MARKUPS

# Consolidated Edison Company Of New York

## Indian Point 2

## NRC Regulatory Conference

## **IP2 Row 2 U-Bends With Hour-Glassing**

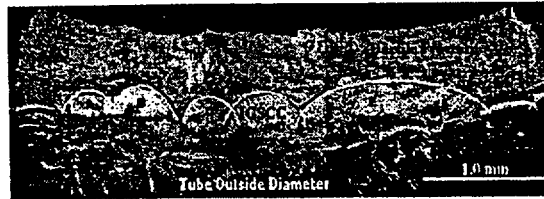
CRACK  
IS  
LONGITUDINAL

- SKEWED  
- OR  
STRAIGHT -
